FAQ Number 12-0061 FAQ Revision 0

FAQ Title NFPA 805 Change Process

Plant: NEI Date: July 6, 2012

The purpose of this FAQ is to incorporate lessons learned and clarify the following NFPA 805 Post Transition Change Evaluation Process:

Figure 5-1 – Fire Protection Change Impact Review Process

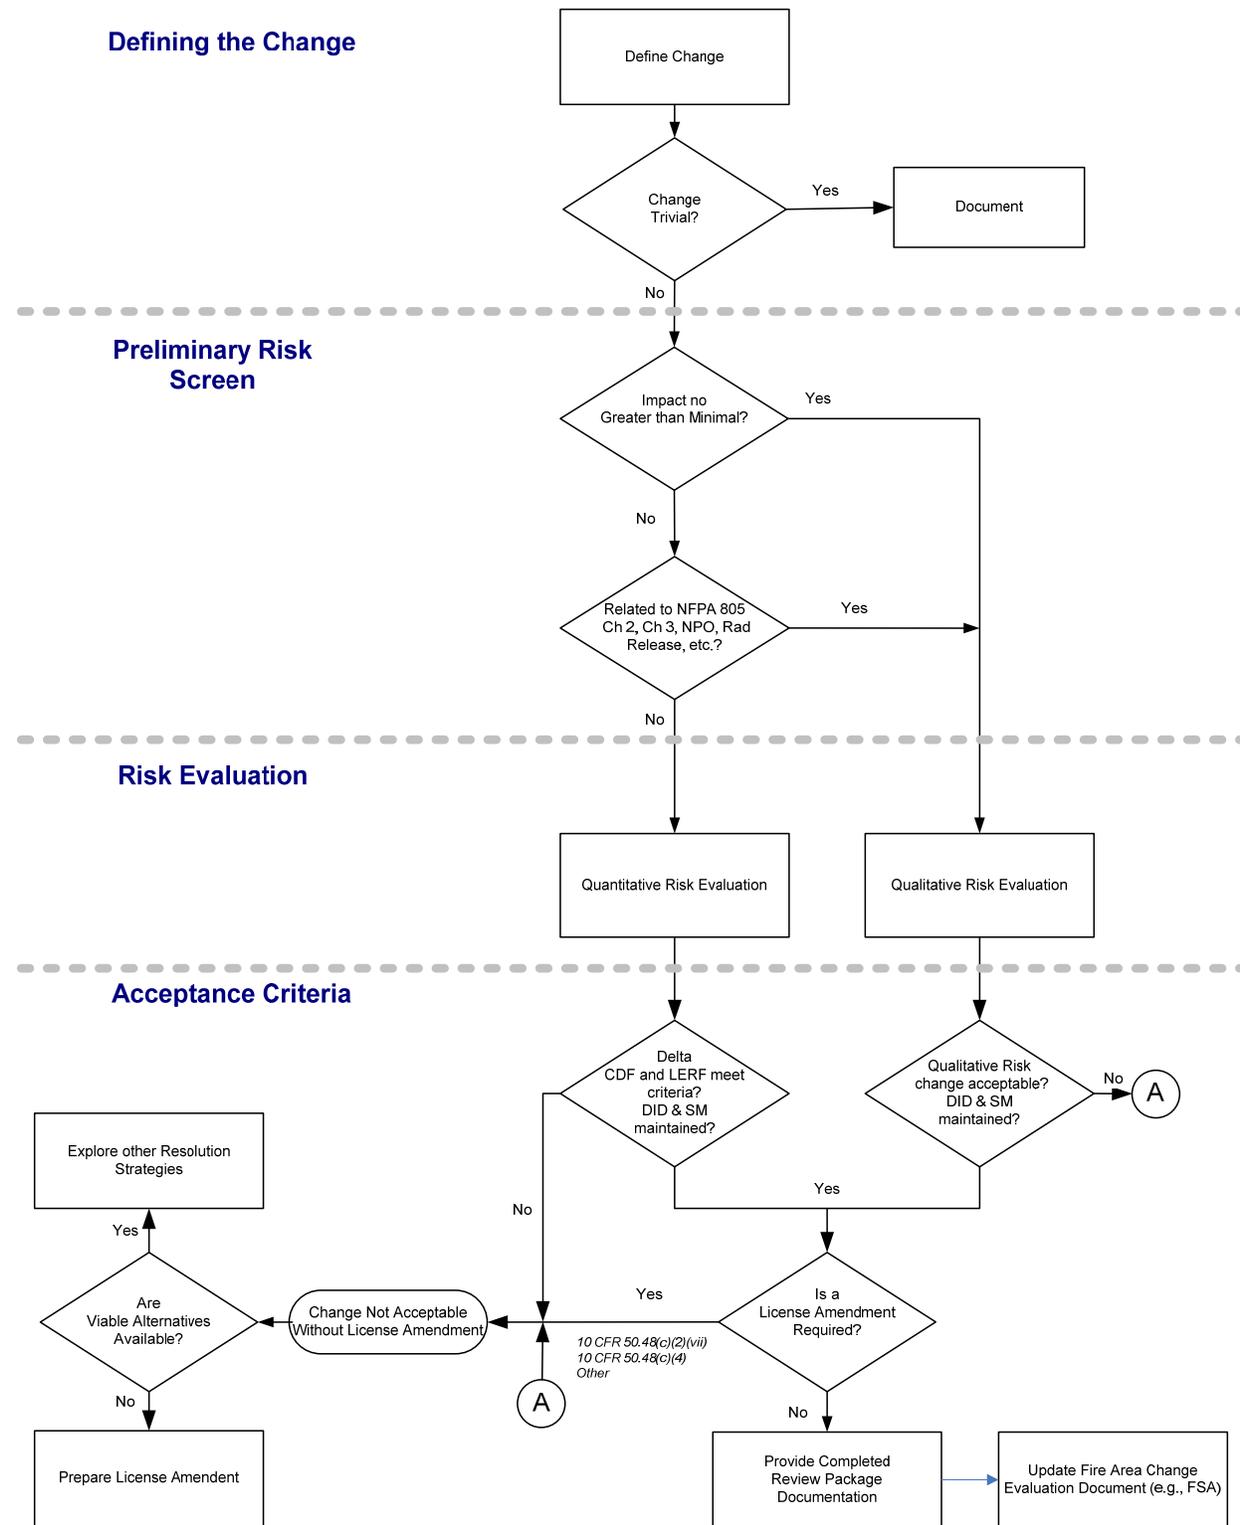
Figure 5-1 depicts the Fire Protection Change Impact Review Process. The Fire Protection Change Impact Review can be divided into the following subtasks:

- Defining the Change (See Section 5.3.2)
- Performing the Preliminary Risk Screening (See Section 5.3.3)
- Performing the Risk Evaluation (See Section 5.3.4)
- Reviewing the Acceptance Criteria (See Section 5.3.5)

Figure 5-2 – Compliant versus Changed/Altered Conditions (for an example risk increase)

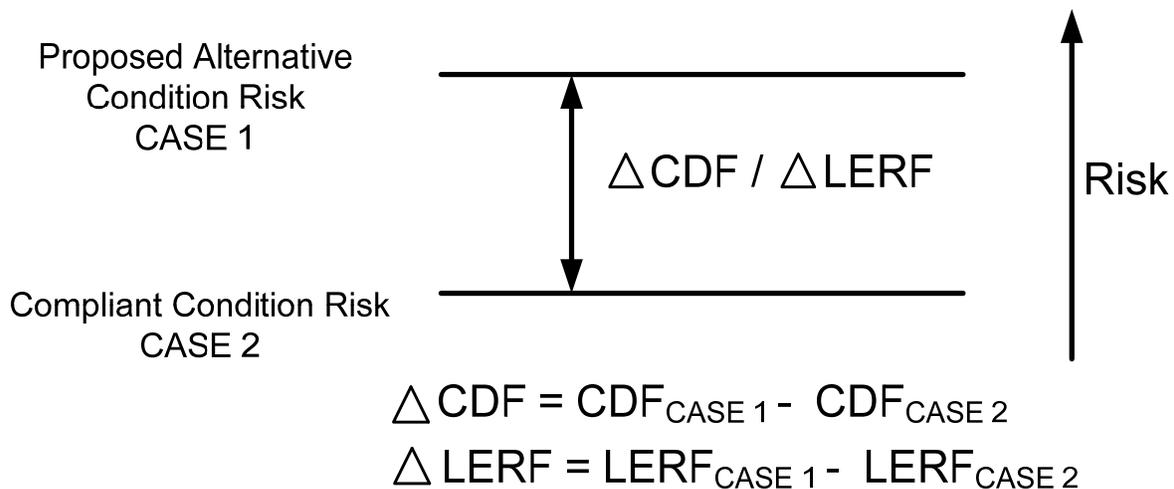
The quantitative Change Evaluation process begins by defining the change or altered condition to be examined and the compliant configuration as defined by the NFPA 805 Licensing Basis:

- The changed or altered condition or configuration that is not consistent with the NFPA 805 Licensing Basis is defined as the proposed alternative (Case 1)
- The compliant condition is defined as that plant condition or configuration that is consistent with the NFPA 805 Licensing Basis (Case 2).

Note that the compliant condition (Case 2) is the risk associated with the NFPA 805 licensing basis, but not necessarily deterministic compliance with Section 4.2.3 of NFPA 805. It is also relative to the latest revision of the plant Fire PRA that has been evaluated per the process in Appendix J, Section J.6.2, Treatment of Cumulative Program Changes.

Figure J-1 – Fire PRA Treatment of Cumulative Risk

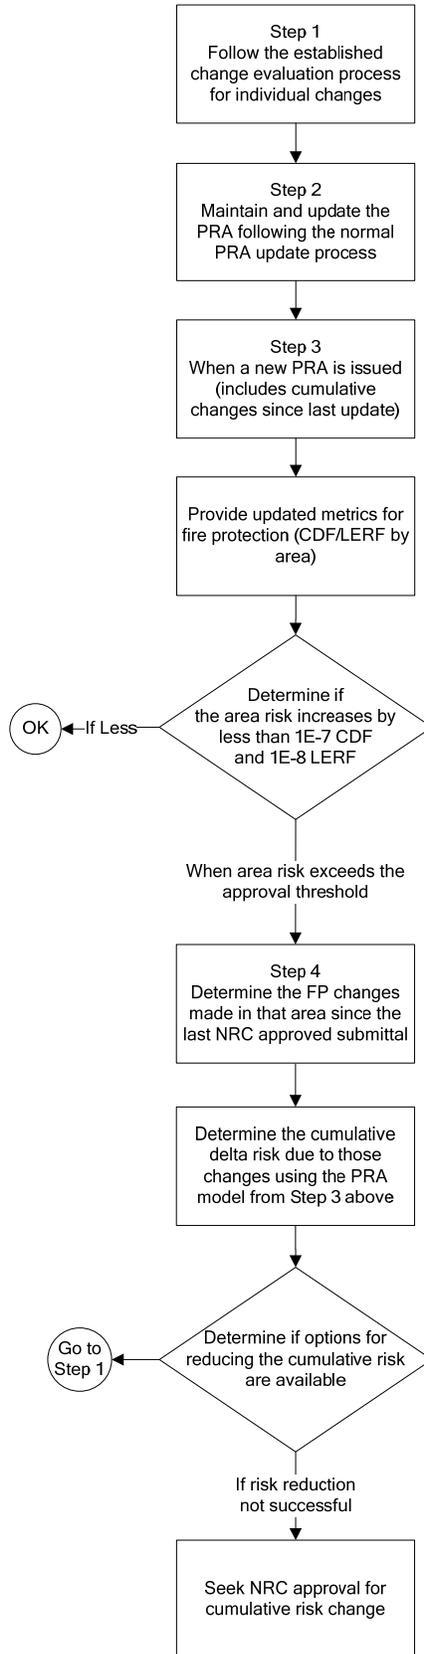
Figure J-1 depicts the process to evaluate cumulative impact of changes to the Fire Protection Program.

- Step 1 - Follow the established Fire Protection Change Impact Review process for individual changes using the Fire PRA of record.
- Step 2 - Maintain and update the Fire PRA following the normal Fire PRA update process

- Step 3 - When a new PRA is issued (which includes the cumulative impact of changes since last update in addition to the impact of all the plant changes in previous updates)

- Provide updated metrics for fire protection (CDF/LERF by area).
 - Determine if the fire area risk increases by less than 1E-07 CDF/yr and 1E-08 LERF/yr. If risk is lower than threshold, cumulative risk change is satisfactory. These are conservative change in risk threshold values consistent with the license condition values from Regulatory Guide 1.205, Revision 1.

- Determine the cumulative delta risk due to those fire protection changes using the PRA model from Step 3 above. Use of the current Fire PRA model ensures the most accurate and appropriate measure of risk and change in risk.

Note: This condition should be documented in the plant corrective action program and appropriate compensatory measures implemented. Note that if the process is utilized as intended, this condition is not reportable as it is part of the process to check for impacts of cumulative changes within the same Fire Area.

- If risk reduction not successful and the permission is desired for the current plant configuration, then treat this condition as a plant change and seek NRC approval for cumulative risk change.
